City of Kodiak
St. Paul Harbor Fender Piling Replacement
PN 21-07/8523
Addendum No. 3
February 22, 2024

The following change(s) and/or clarification(s) are made to the Plan and Specification Documents of Invitation to Bid for the St. Paul Harbor Fender Piling Replacement PN 21-07/8523:

SIGNAGE AND STRIPING PLAN

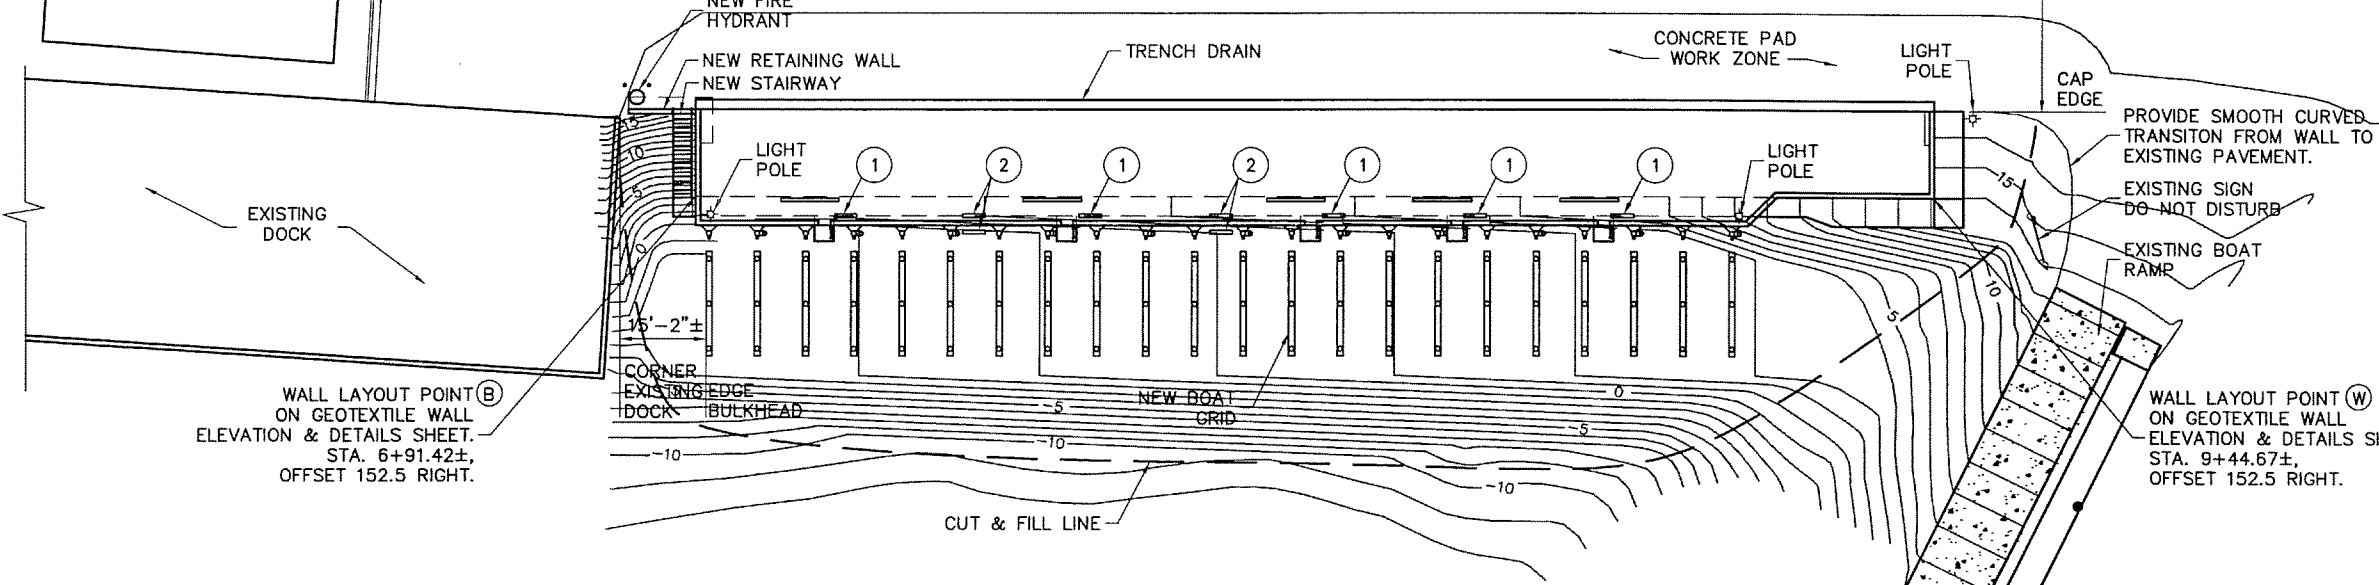
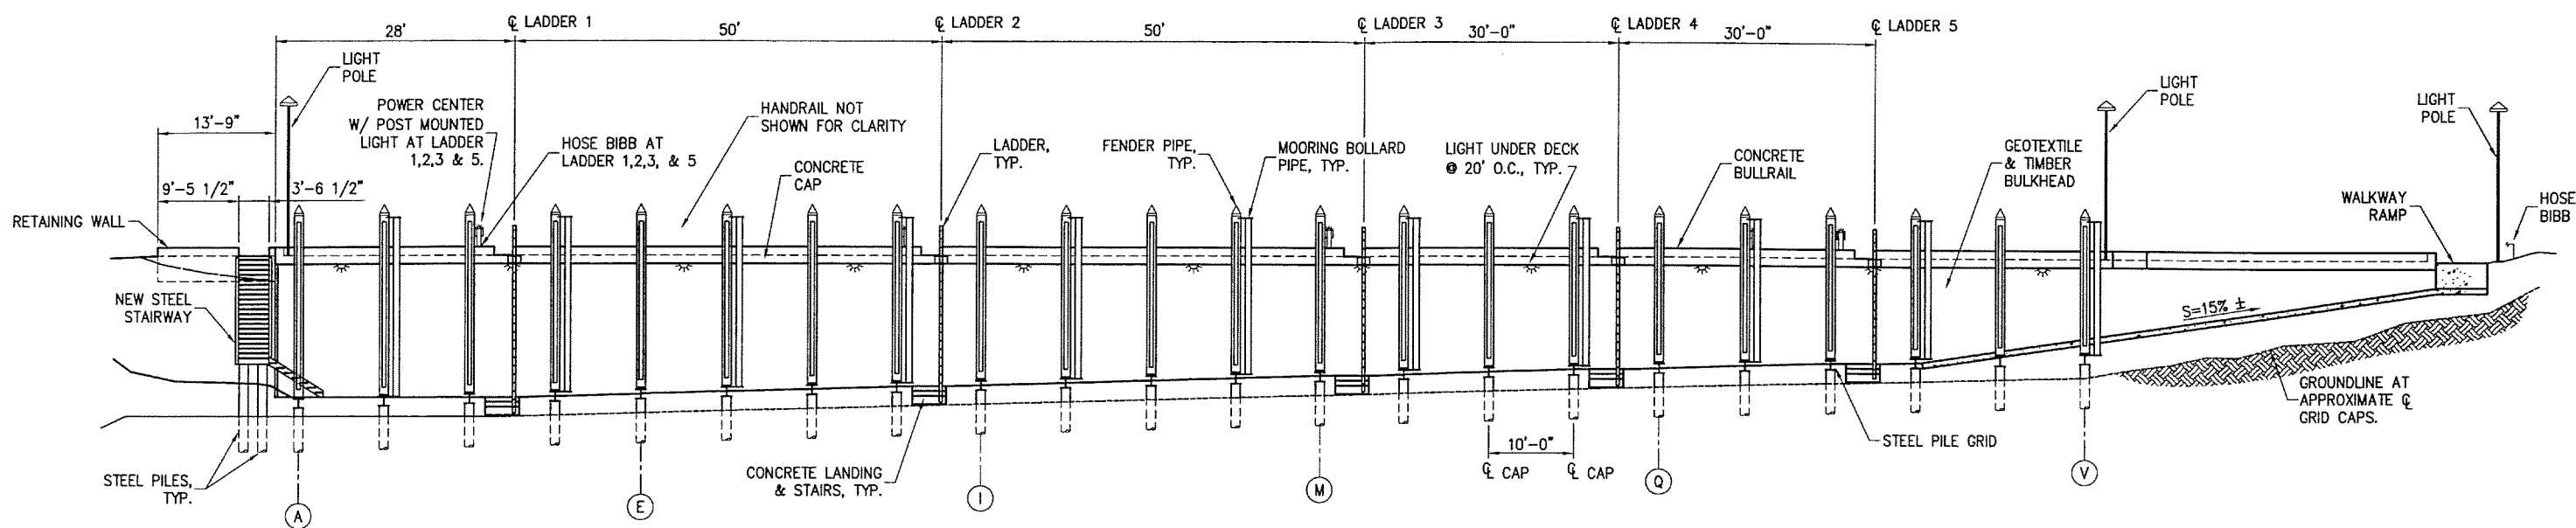
- f. Can a barge be moored to the face south of Dock 1?

Answer: Any barge or moorage operations shall avoid the harbor grid adjacent to Dock I. See attached drawings "St. Paul Harbor Boat Grid" (2 pages)
